Director of Community and Economic Development

UPDATE

June 27, 2022
Updated 6-27-2022

■ Special Permit and Site Plan Review; 203 Ayer Road

Figure 1

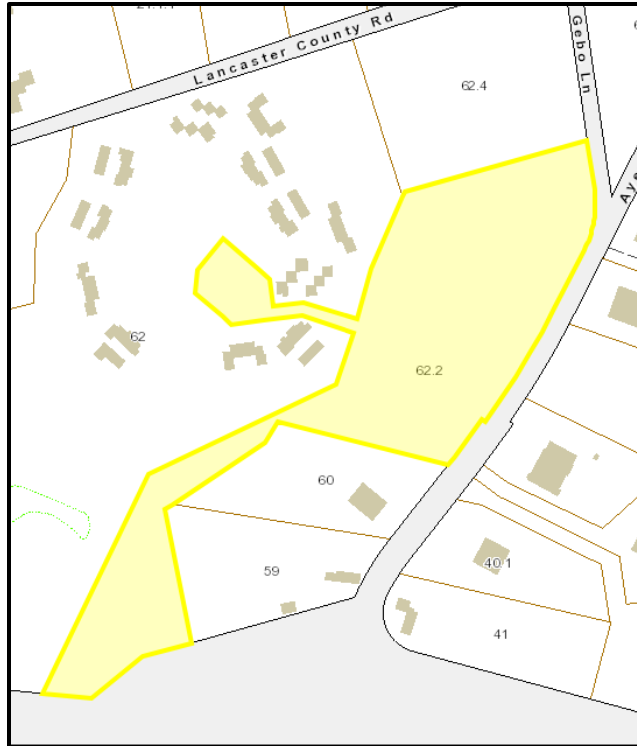
- §125-30.B of the Bylaw requires a total building floor area calculation for all levels of all buildings. Understanding that buildings B & C are not fully designed, as proposed, the Project does not appear to comply with the 10% maximum coverage area. We request that the Applicant clarify the design intent and document compliance with the referenced section of the Bylaw.

As shown above in Figure 1, the Assessors Database and GIS show the current legal lot at 11.9 acres. This complete lot is not shown on the site plan. Further, the site plan states the lot size at 11.03 acres suggesting that part of the lot will be ANR'd off. Given either 11.9 or 11.03 acres, the FAR should be below the 10% threshold because the total proposed floor area is 42,615 s.f.
